# Potential Mohave Ground Squirrel Impacts Solar Millennium Ridgecrest Solar Power Project

Dave Hacker, Staff Environmental Scientist  
California Department of Fish and Game  
May 4, 2010

**09-AFC-9**

# Is there Population Connectivity Between MGS Core Areas?

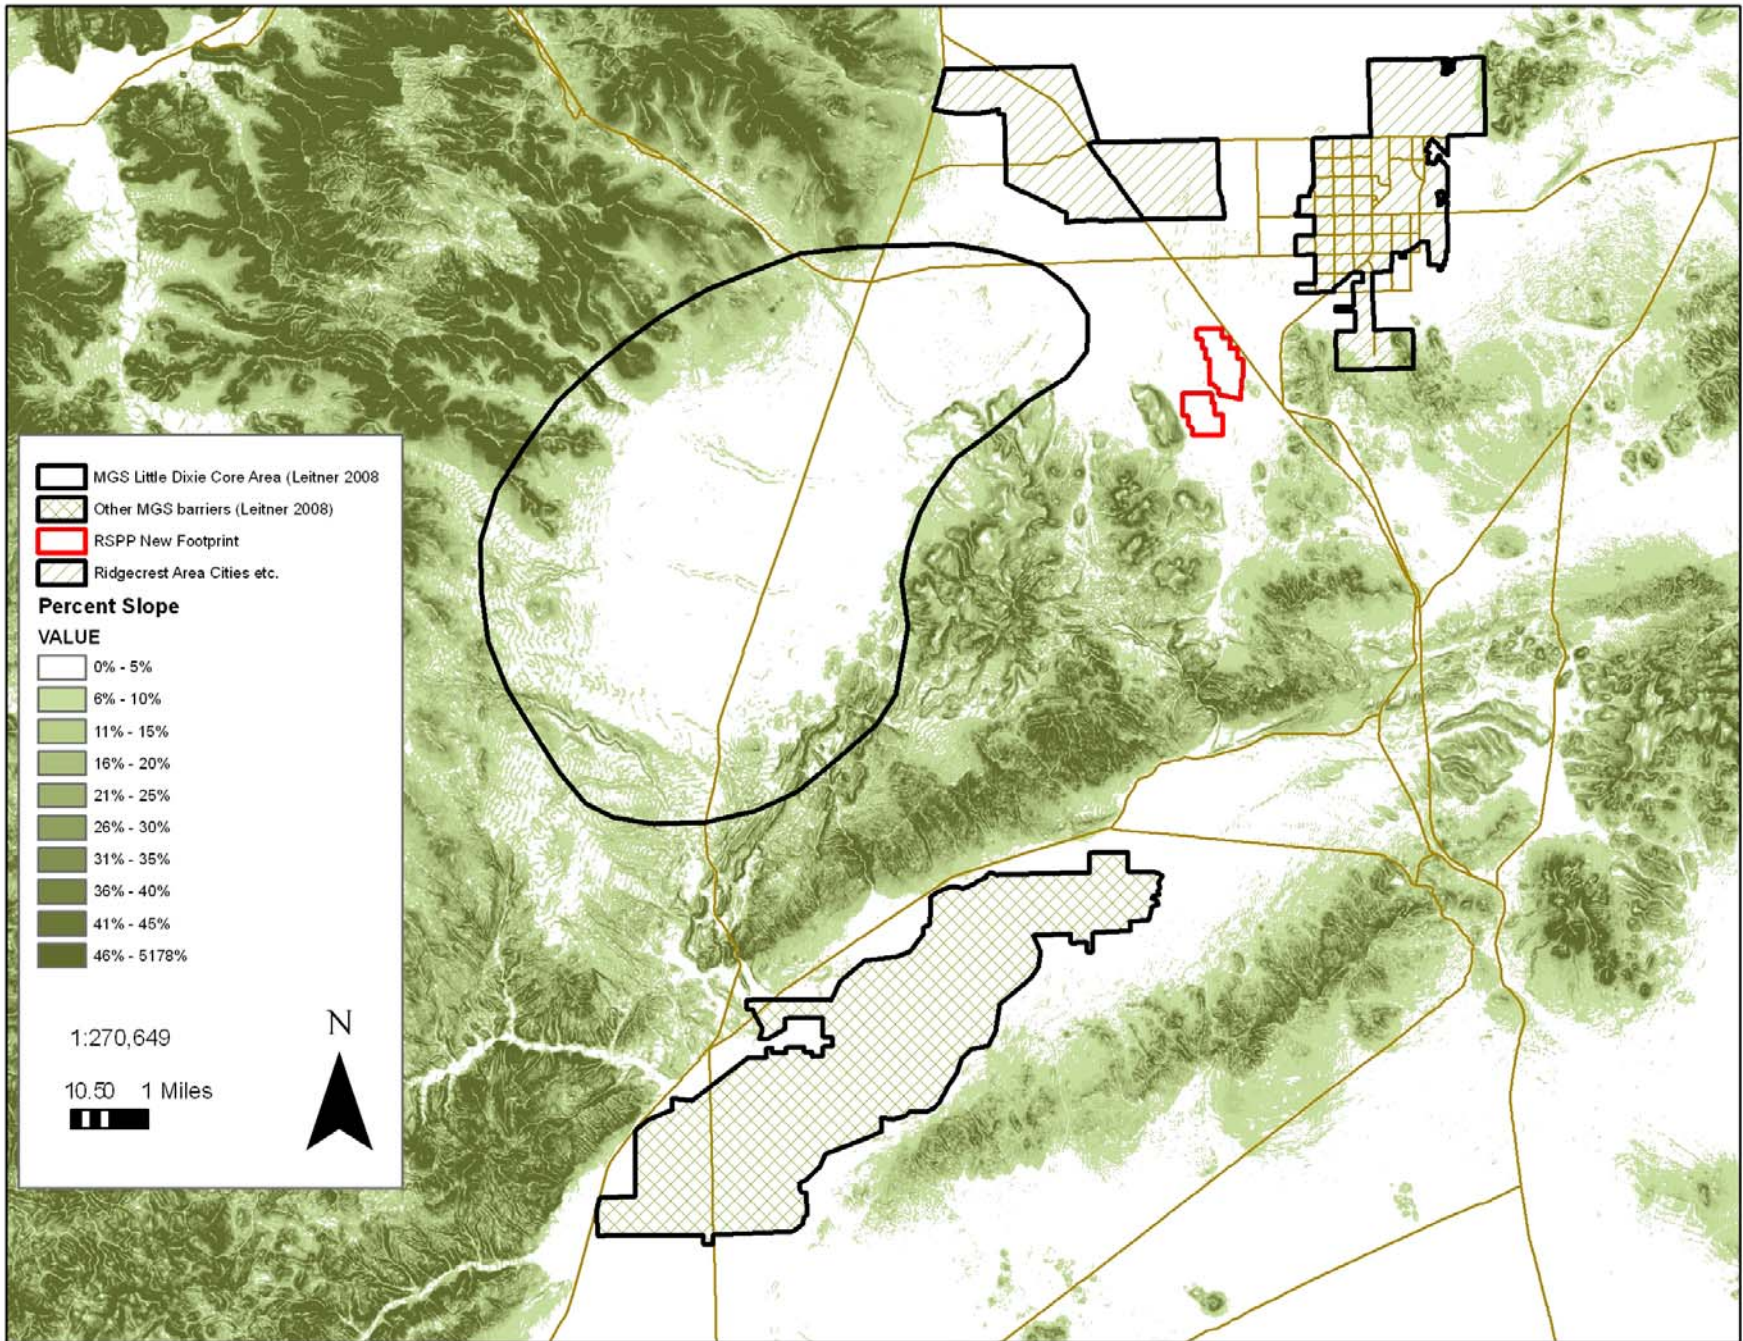
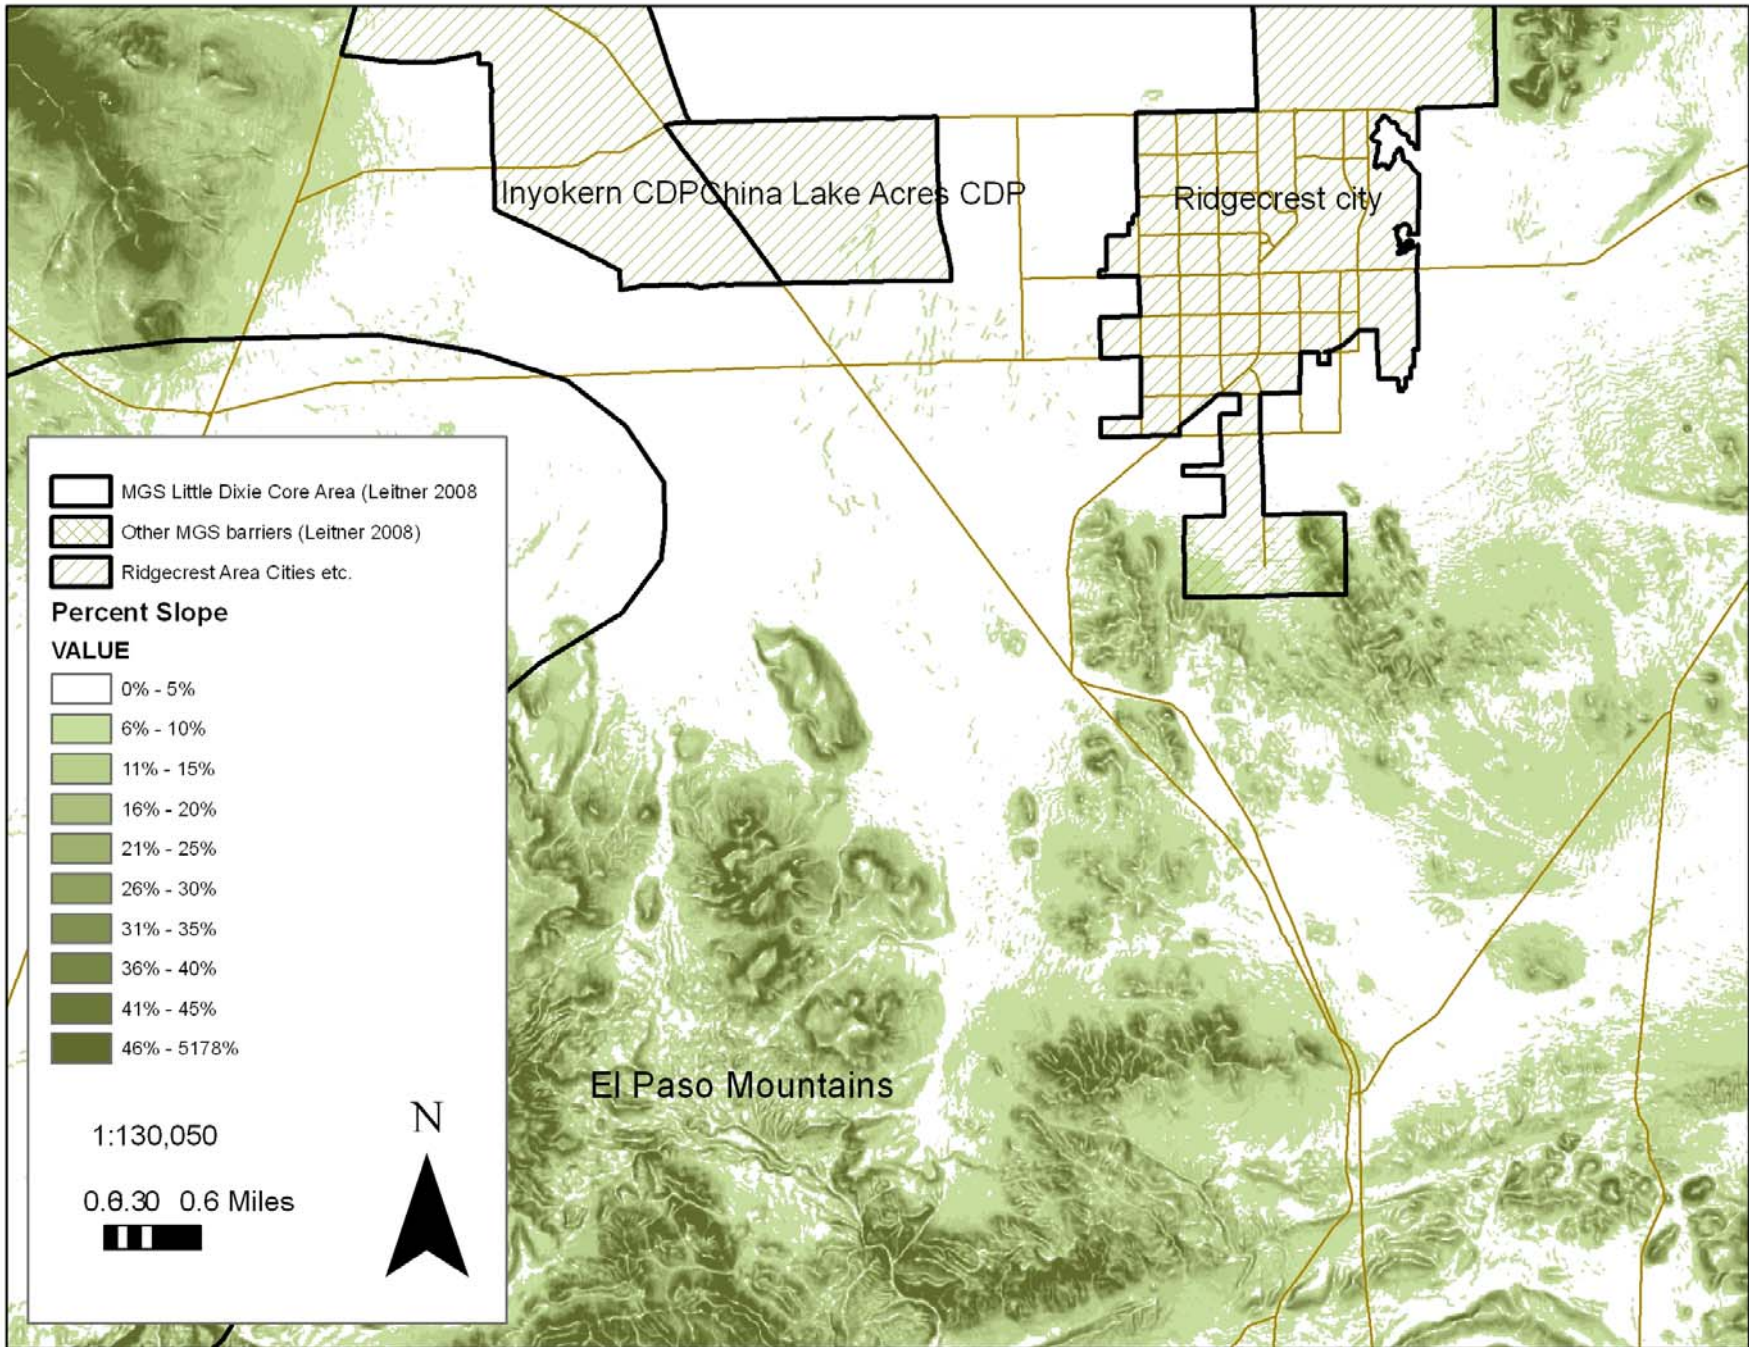
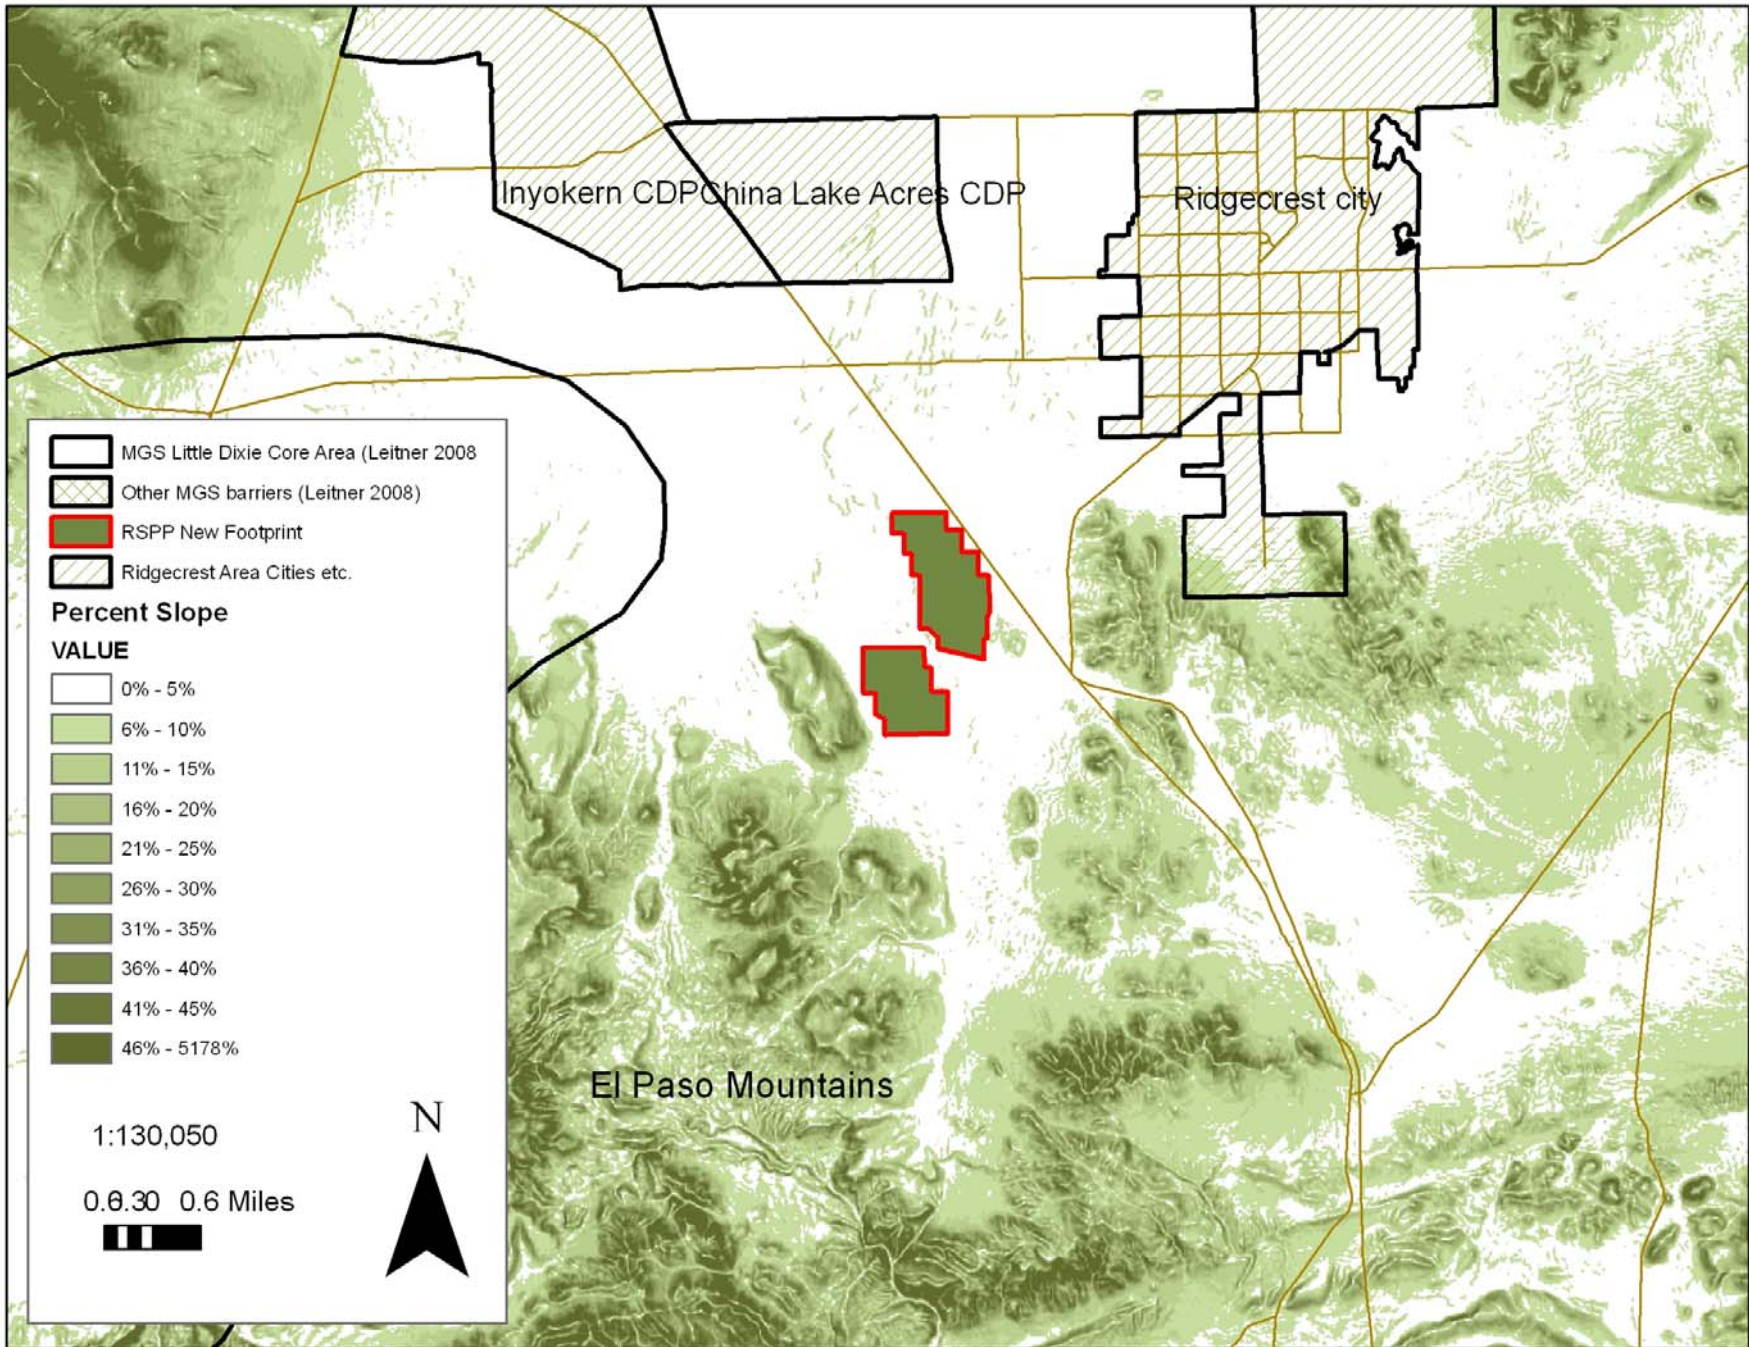
UN Reno (Marjorie Matocque) genetics work suggests some isolation of Little Dixie Wash and Coso populations, but also evidence of on-going exchange between all of the groups, including Little Dixie Wash.
